DART AEROSPACE LTD	Work Order:	96758
Description: Crosstube Assembly (206L High Fwd)	Part Number:	D206-667-143
Inspection Dwg: D206-667-143 Rev: C		Page 1 of 2

DRAWING NO. D206-667-143	TITLE CROSSTUBE ASS'Y (206L HIGH FWD)	REV. C	DART AEROSPACE LTD ENGINEERING ORDER		D.E.O. NO. D206-667-143-C-1	SHEET NO. SHEET 1 OF 1	SCALE NTS
DRAWN 9	CHECKED ASS	MFG. APPR. [Signature]	APPROVED [Signature]	DE APPR. [Signature]			
DATE 11.07.15	DATE 11.07.20	DATE 11.07.21	DATE 11/07/21	DATE 11.07.21

DRAWING NO. D206-667-143		TITLE CROSSTUBE ASS'Y (206L HIGH FWD)		REV. C DART AEROSPACE LTD ENGINEERING ORDER		D.E.O. NO. D206-667-143-C-2		SHEET NO. SHEET 1 OF 1		SCALE NTS	
DRAWN AJS		CHECKED		MFG. APPR. <i>E</i>		APPROVED <i>AP</i>		DE APPR. <i>TH</i>			
DATE 12.08.02		DATE 12.08.02		DATE 12.08.02		DATE 12.08.02		DATE 12-08-02

DETAIL P
BONDING STRAP INSTALLATION 2 PL

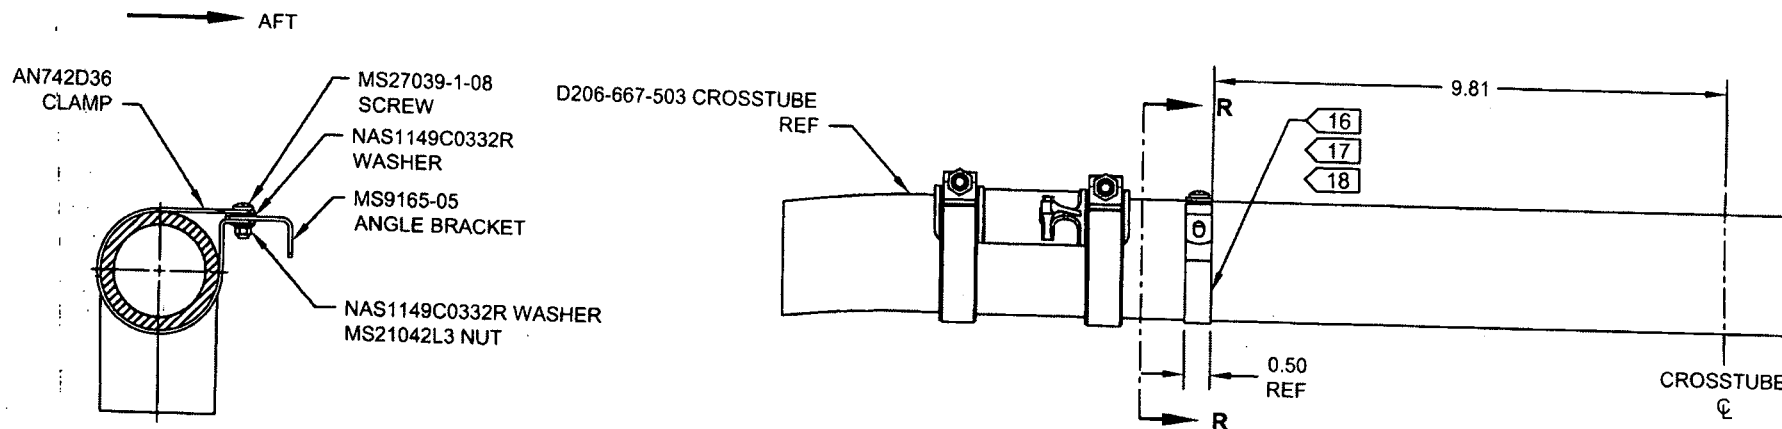
ADD ELECTRICAL GROUNDING STRAP

ADD

- 16) MASK AREA UNDER CLAMP PRIOR TO PAINTING
- 17) SEAL EDGES WHERE AN742D36 CLAMP MEETS WITH THE CROSSTUBE USING SIKAFLEX-241/-291 OR MIL-S-8802 CLASS B2 OR PROSEAL 890 SEALANT
- 18) PERFORM RESISTANCE CHECK TO ENSURE MAX RESISTANCE IS 10 MILLIOHMS
